Comal County Environmental Health

Permit of Authorization to Construct an On-Site Sewage Facility Permit Valid For One Year From Date Issued

Permit Number: 118021
Issued This Date: 11/07/2024
This permit is hereby given to: CHRISTOPHER GUERRA

2855 WESTERN SKIES DR
SPRING BRANCH, TX 78070

OWNER: CHRISTOPHER GUERRA			DRAWN BY: EJS III/GWJ	
STREET ADDRESS: 2855 WESTERN SKIES DRIVE				
LEGAL DESC: CYPRESS LAKE GARDENS-HIGH COUNTRY SECTION			BLOCK: 109	LOT: 5
PREPARED BY: GREG W. JOHNSON, P.E. F#002585		SCALE: 1"=20'	DATE: 10/8/2024	REV3: 05/16/2025

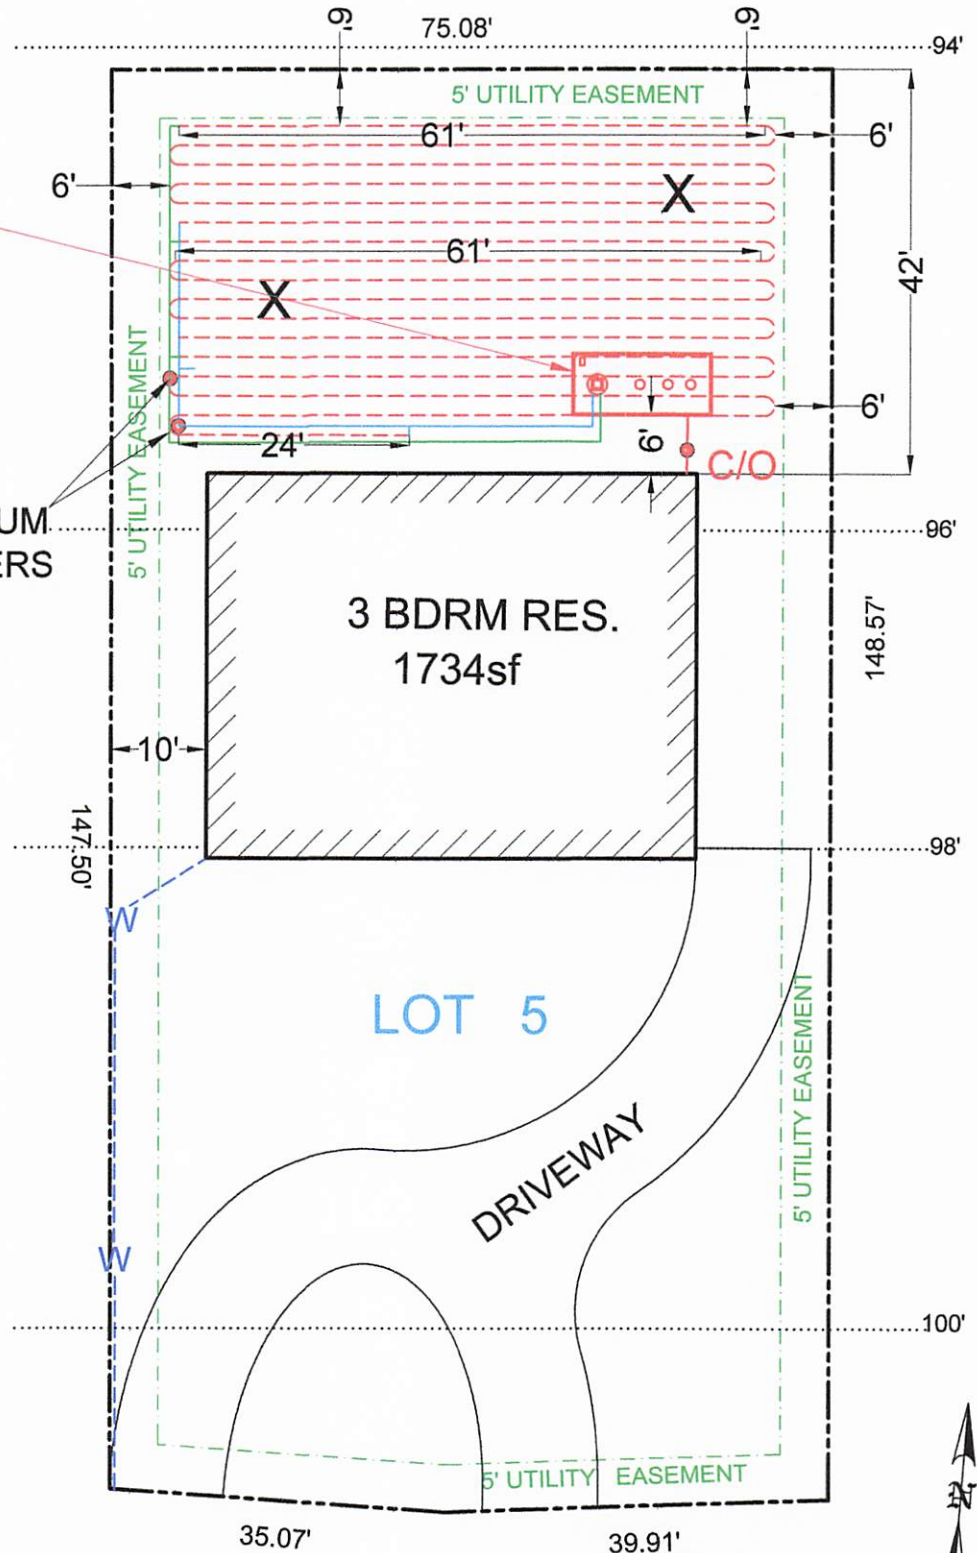
Revised to allow for Curlex erosion control blankets and heavy seeding.

OWNER: CHRISTOPHER GUERRA				DRAWN BY: EJS III/GWJ	
STREET ADDRESS: 2855 WESTERN SKIES DRIVE					
LEGAL DESC: CYPRESS LAKE GARDENS-HIGH COUNTRY SECTION				BLOCK: 109	LOT: 5
PREPARED BY: GREG W. JOHNSON, P.E. F#002585		SCALE: 1"=20'	DATE: 10/8/2024		REVISED: 01/17/2025

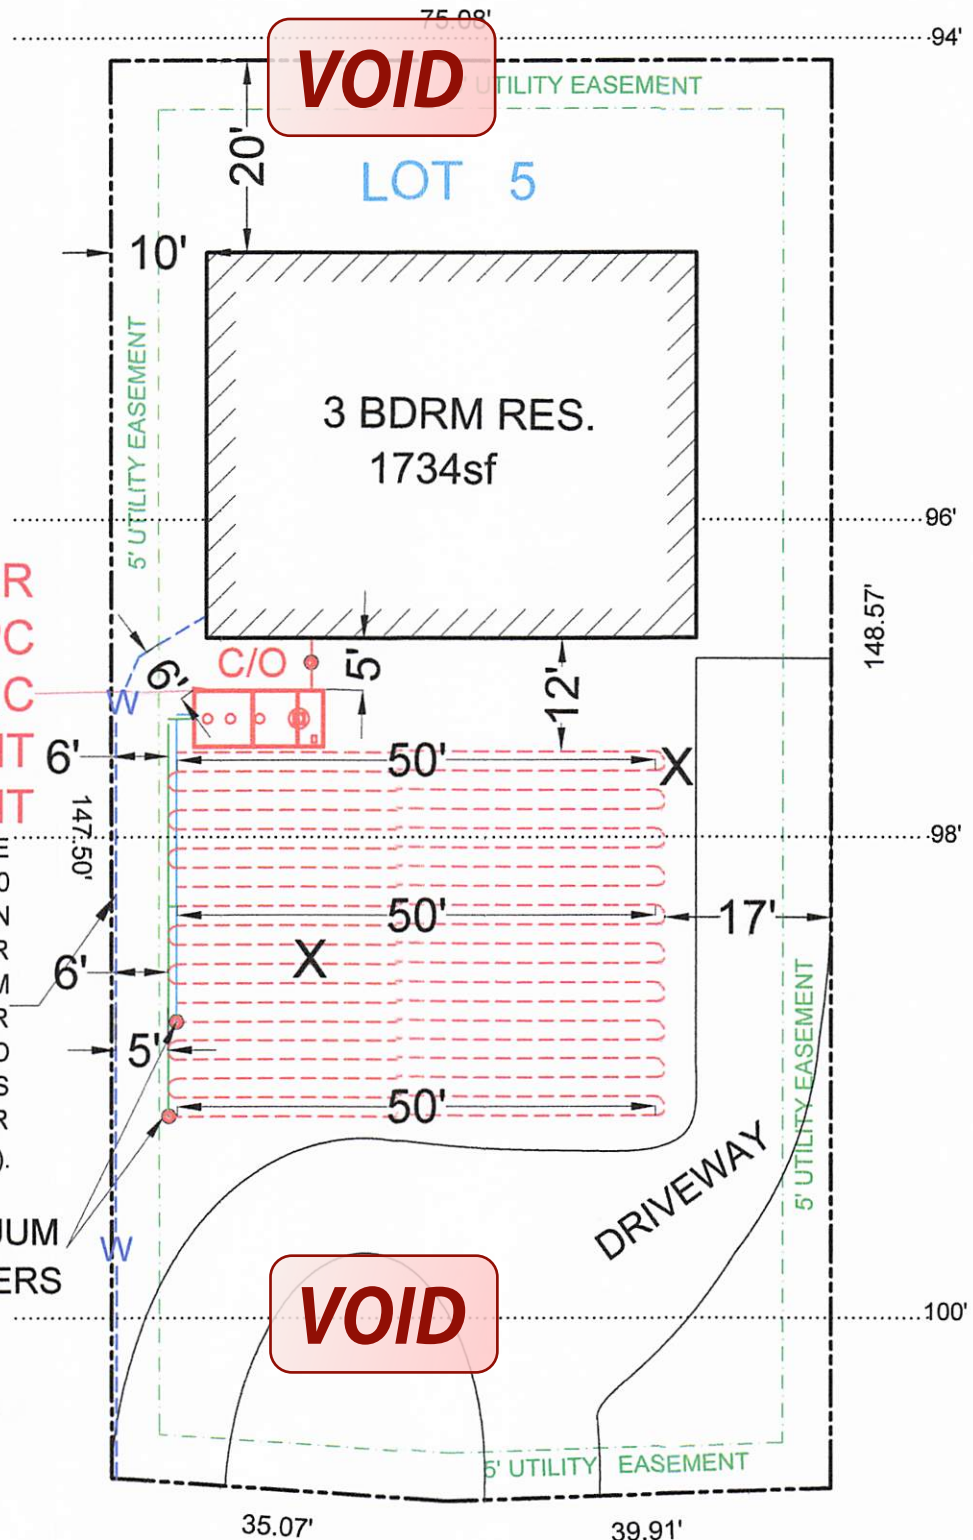
1. ✓ Submit a variance request for the water line within close proximity to the drip field.
2. ✓ A minimum of 12 inches of suitable soil is required below the drip tubing. The installation details do not ensure that this requirement will be consistently met.
3. ✓ A preliminary inspection is scheduled for tomorrow. Additional comments may be necessary once complete.
4. Revise as needed and resubmit.
